## Car Parks for Commuters Project – Eltham and Wattle Glen

## Submission from the Nillumbik Shire Council to the Level Crossing Removal Project (LXRP)

14 September 2021

Two large trees anticipated to be removed for the extended maintenance yard.

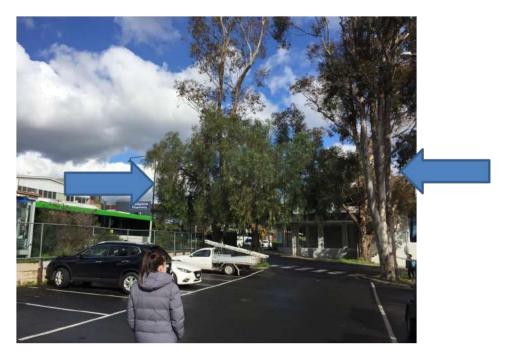
It is evident that the project proposes to remove two large trees in order to provide for vehicle movement from the relocated maintenance yard. This would be highly disappointing, as not only are the trees significant in size, but they also play an important role in buffering the Eltham Childcare Co-operative from the hard uses and development associated with the railway precinct (e.g. stabling, parking, train movements). The removal of these trees would be inappropriate.

- Trees located between Main Road and the railway line;
- Vegetation located along Youth Road and in the existing station car parking which is adjacent to Youth Road; and
- The two trees located just north of the Eltham Childcare co-operative, which should be retained in response to Council's request that the State Government not acquire part of 16 Panther Place.
- Redesign the proposal so that any provision of additional bicycle parking is
  protected and secure, and any additional bicycle parking on the eastern side
  of the railway line is integrated with existing secure and protected bicycle
  parking.
